**ADDENDUM No. 2**  
**Request for Competitive Sealed Proposals (CSP)**  
**19CSP104 Renovations at Dobie Middle School**

**Addendum No. 2**

**TO:** Prospective Bidders  
**FROM:** Haddon+Cowan Architects  
**SUBJECT:** AISD Dobie Middle School Renovations

**DATE:** February 15, 2019  
**HCA PROJ. NO:** 18-1032  
**AISD PROJ. NO:** 190035-DOBIE

**4 EXTERIOR WALL JOINTS**  
SCALE: NTS

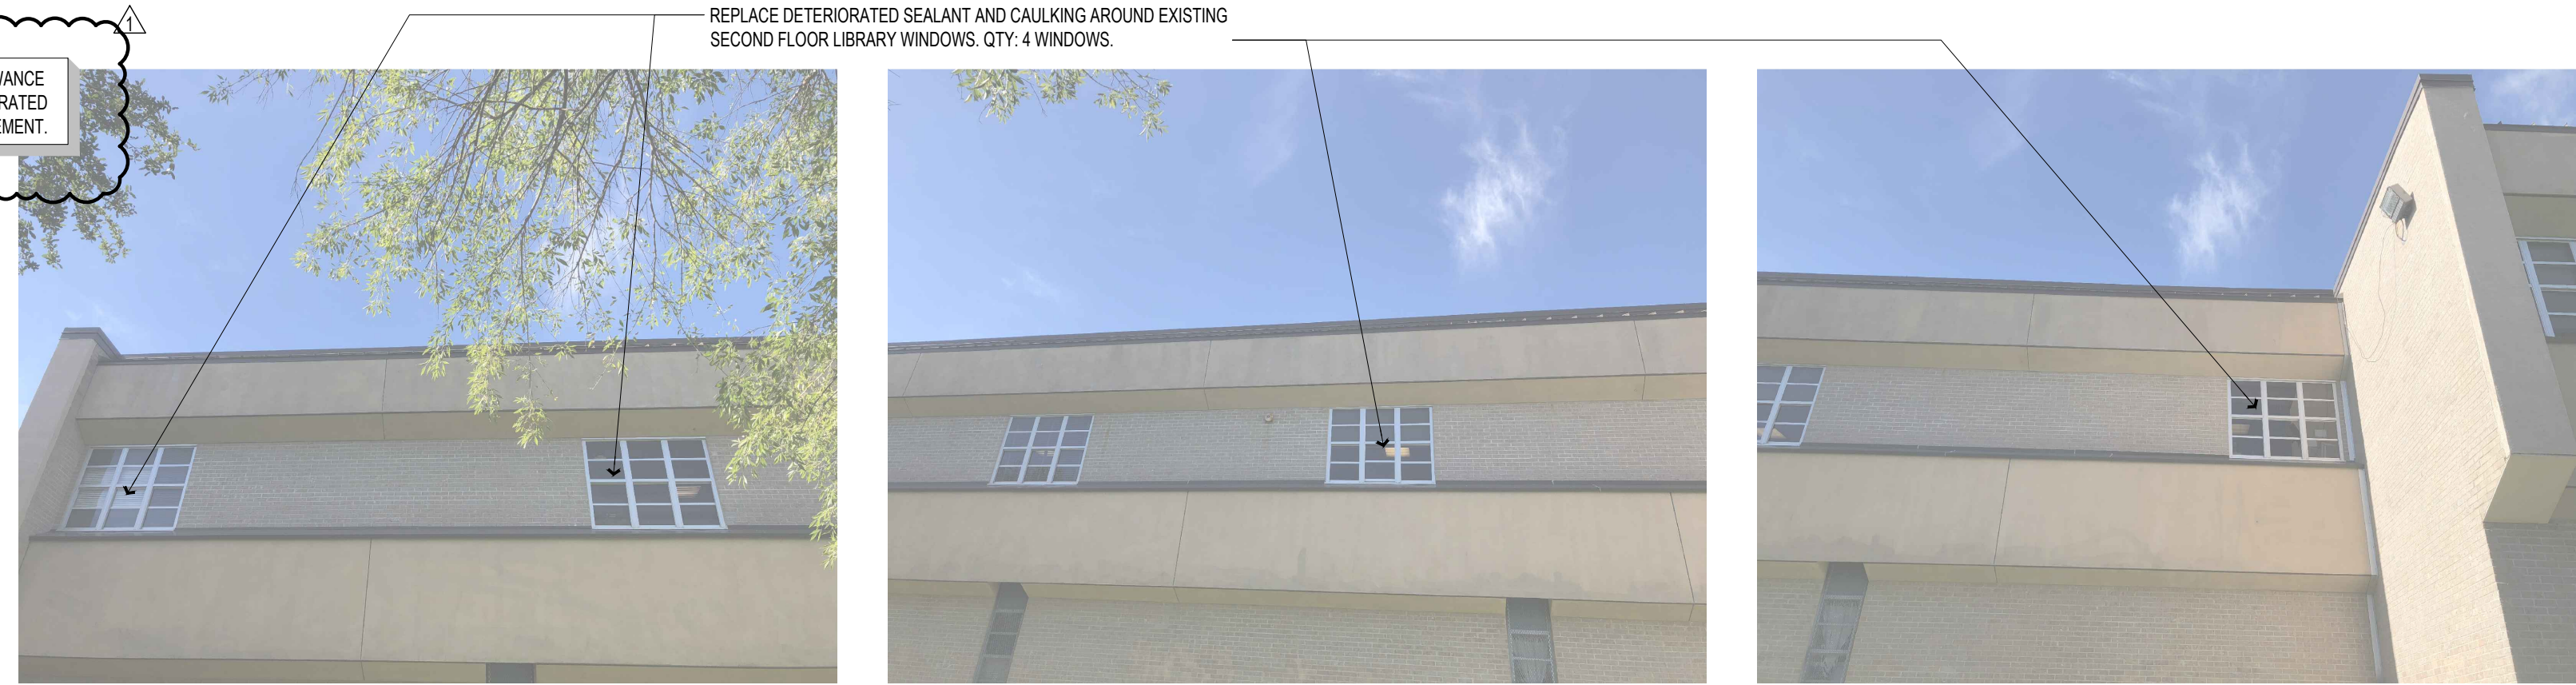
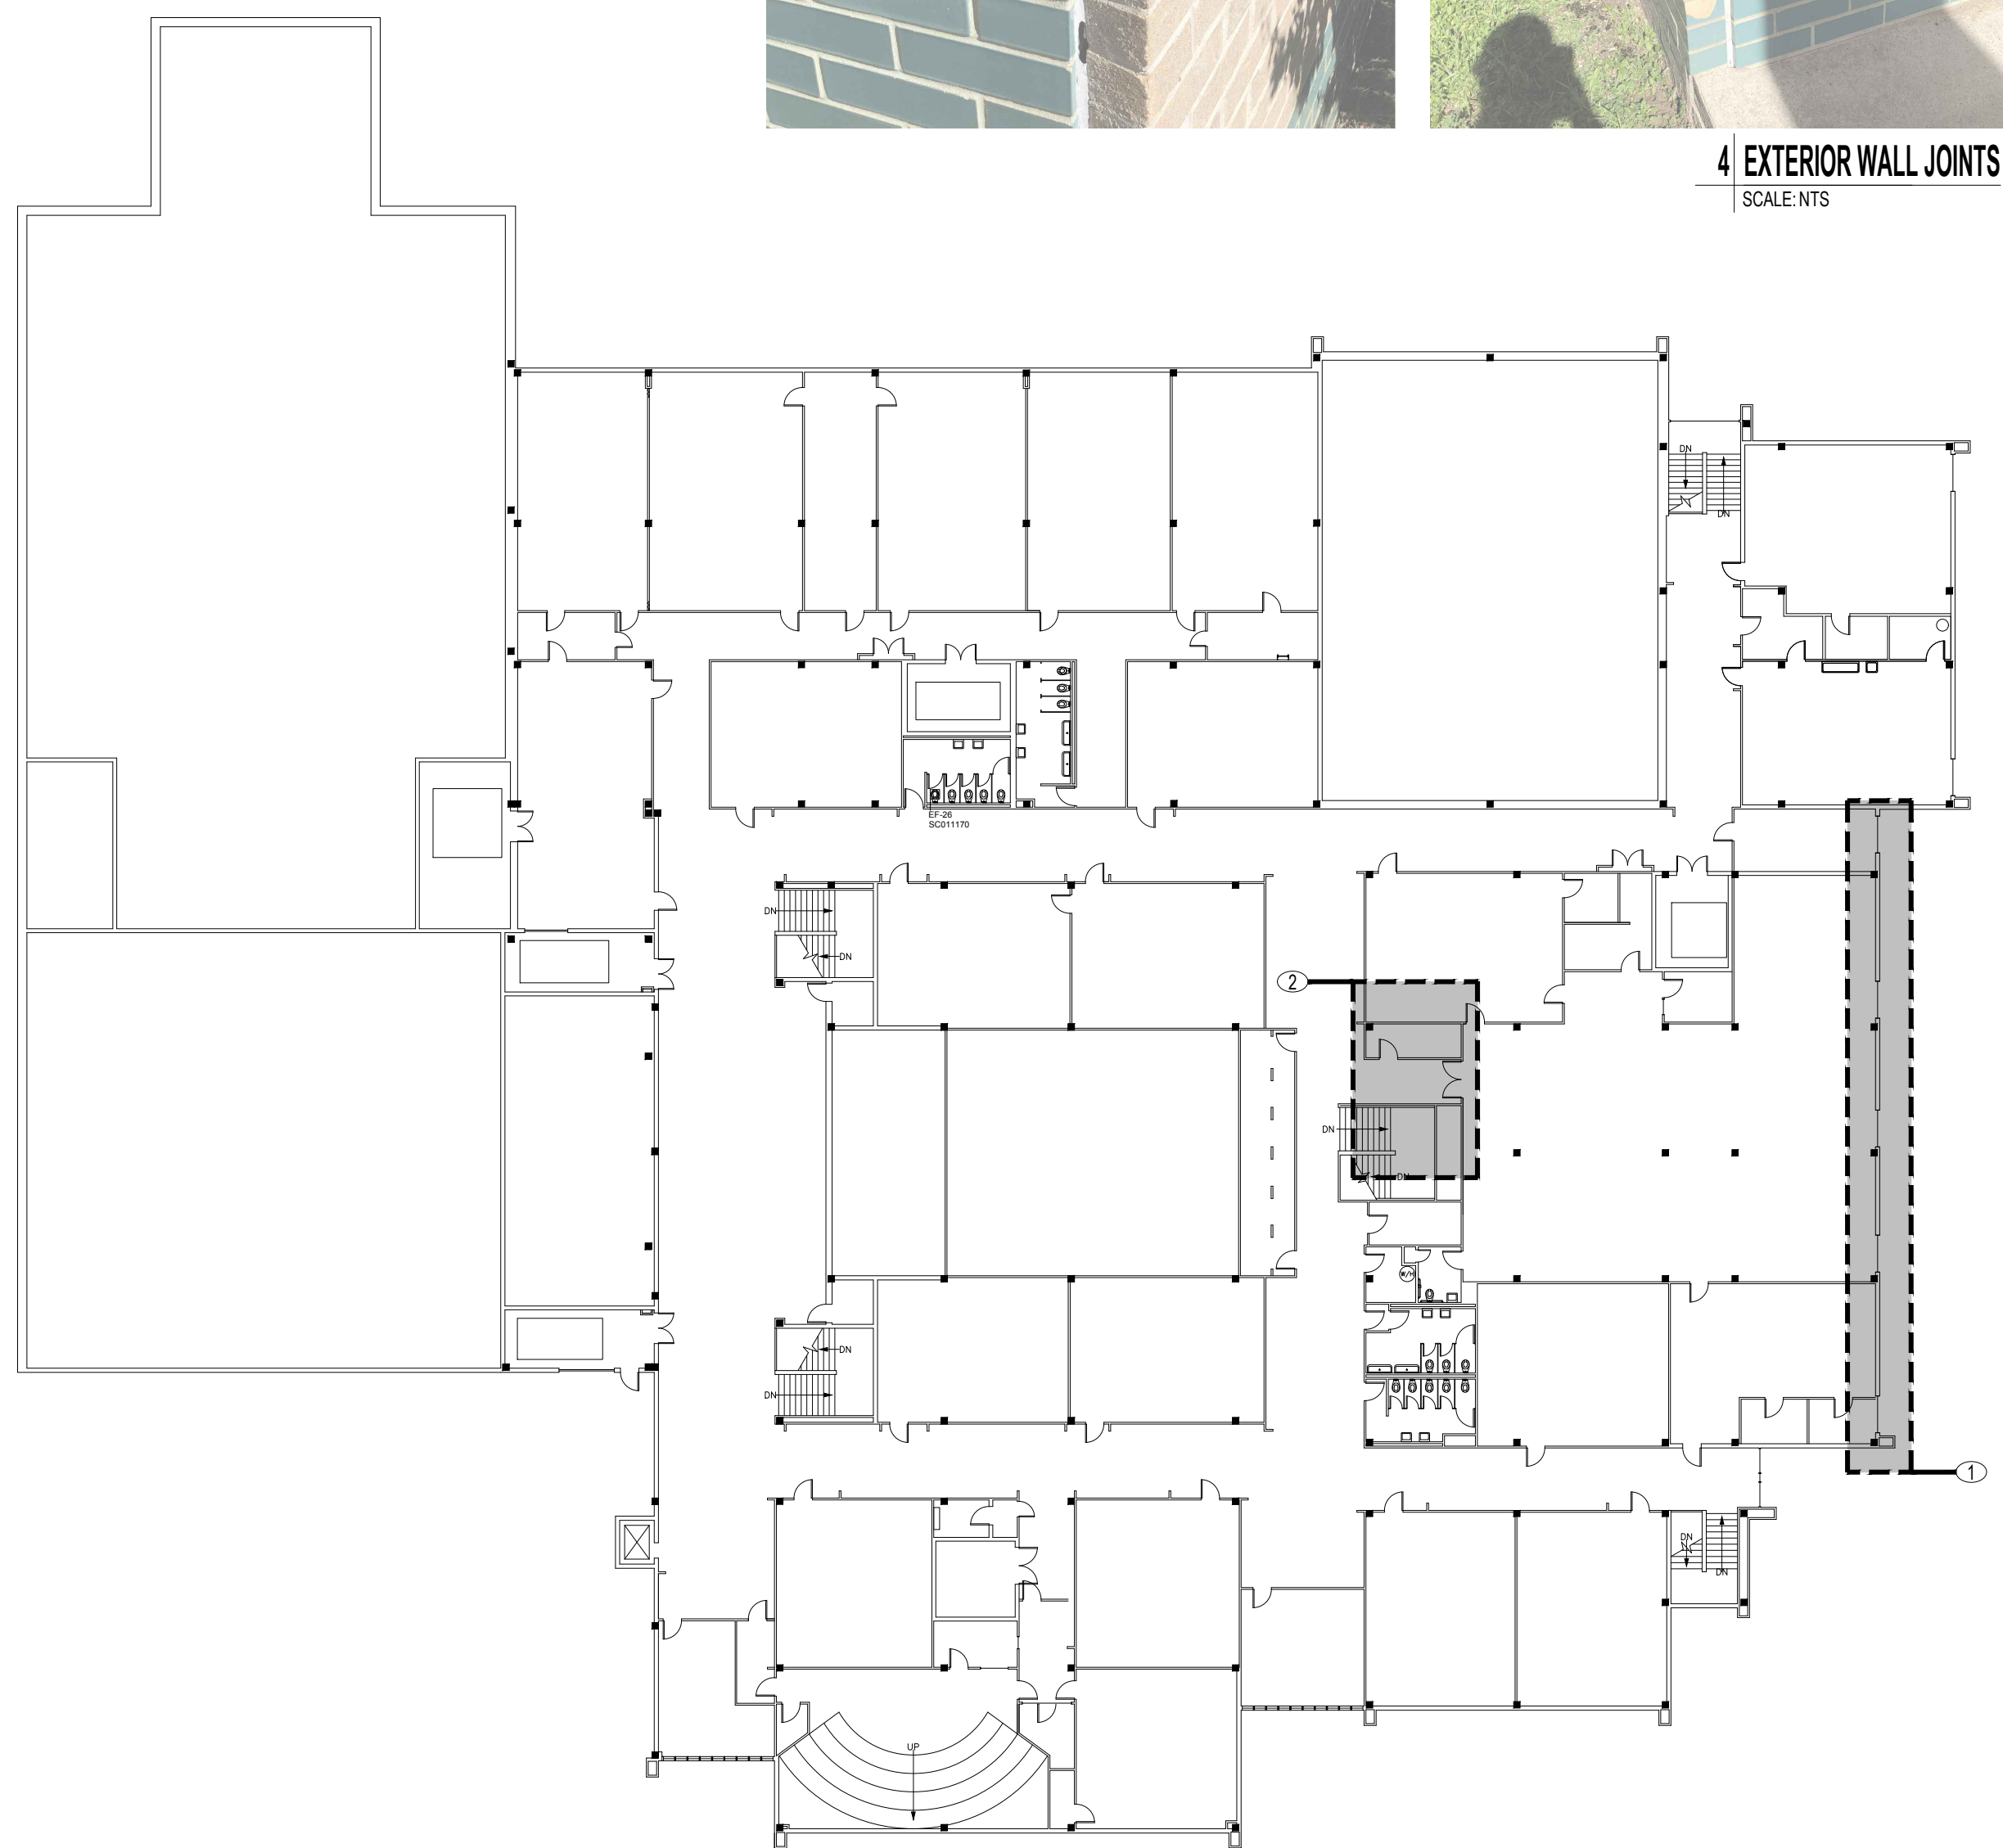
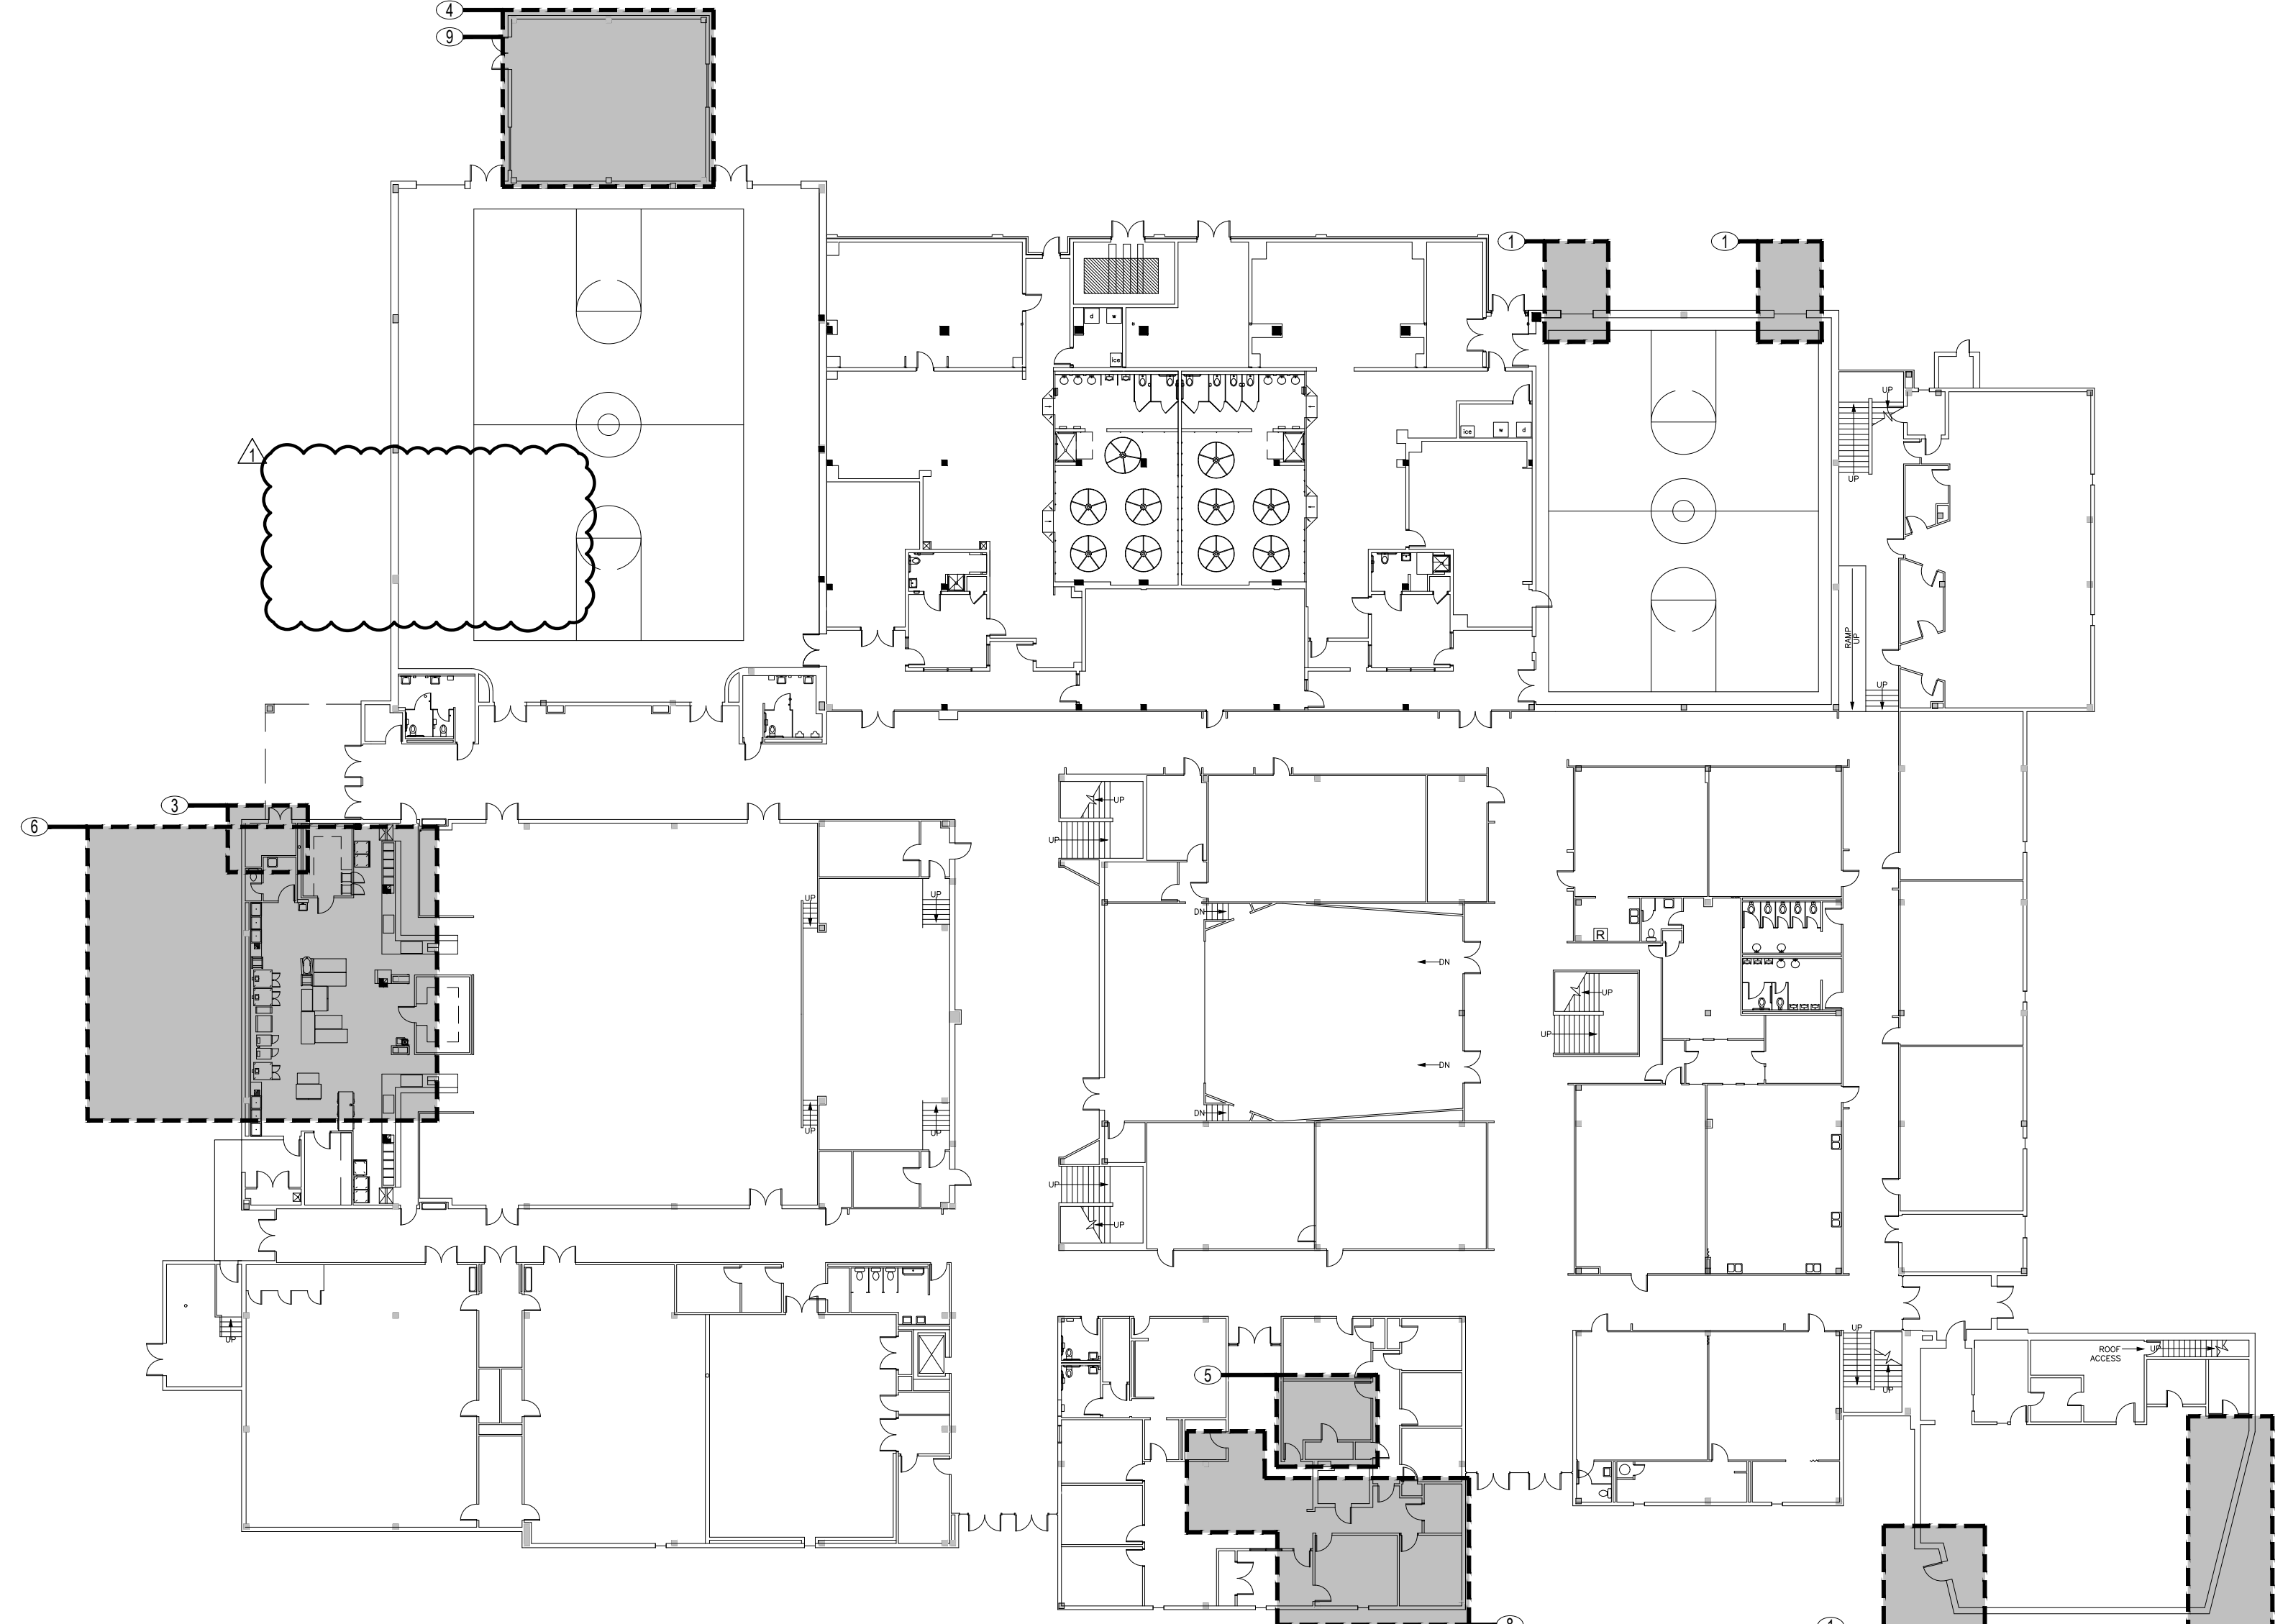
1. Sheet G0.01 – Revised and Reissued
  - a. Scope outline note 7 removed from sheet for clarity. Note 7 scope can be found on sheet G0.02.
  - b. Notes added for GC to provide a \$15,000 allowance and unit prices for deteriorated caulk and sealant replacement.

- c. Reference to 3/A3.01 added for scope outline note 4.
2. Sheet G0.02 – Revised and Reissued
  - a. View titles and plan references 6/G0.02 and 7/G0.02 have been revised to 4/G0.02 and 5/G0.02.

GC TO PROVIDE \$15,000 ALLOWANCE AND UNIT PRICE FOR DETERIORATED CAULK AND SEALANT REPLACEMENT.
